**ITEM V-B: MAJOR PROJECT PERMIT MODIFICATION, TENTATIVE SUBDIVISION MAP AND DEVELOPMENT AGREEMENT AMENDMENT – 1581 PARKSIDE WY. – NRSP PCL DC-31C – FILE #2013PL-017**

**REQUEST**

**Figure 3: Proposed Site Plan**

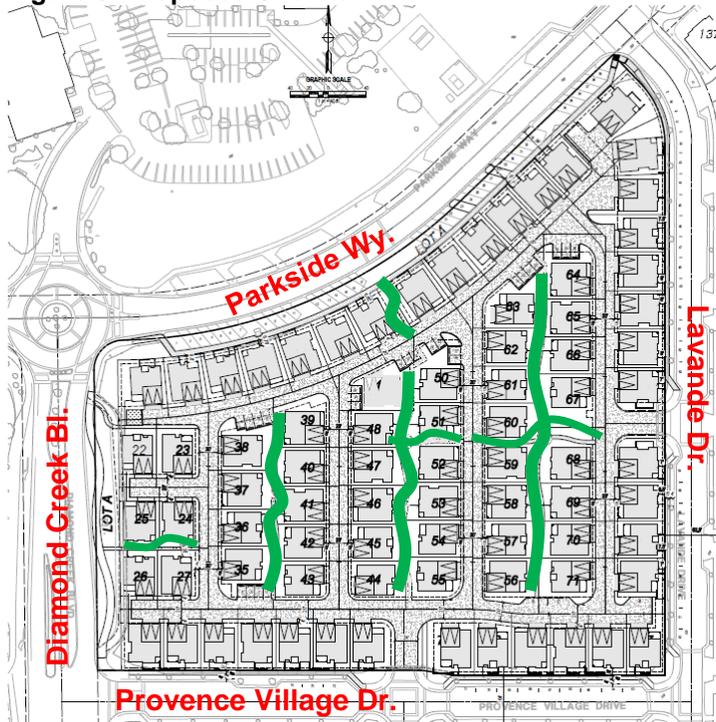
As mentioned previously, the homes will front onto a paseo (shown in green above) or a public street. Internal 20 foot wide private alleyways will provide access to the garages for each home at the rear of the units. These alleyways will be owned by each homeowner and maintained by a Home Owner's Association (HOA).

Parking for the subdivision will be provided within the two car garage spaces of each unit. Guest parking will be provided by 28 onsite spaces dispersed throughout the subdivision with 74 additional on-street spaces provided directly adjacent to the project.

The proposed subdivision design will be consistent with the City's Community Design Guidelines for Compact Residential Subdivisions. The subdivision design will provide pedestrian connections throughout the site to parks and the commercial area to the north. By fronting the homes onto Parkside Wy., Lavande Dr. and Provence Village Dr. the project will provide a strong streetscape presence and will enhance the character of the neighborhood originally envisioned for the Diamond Creek Villages project.
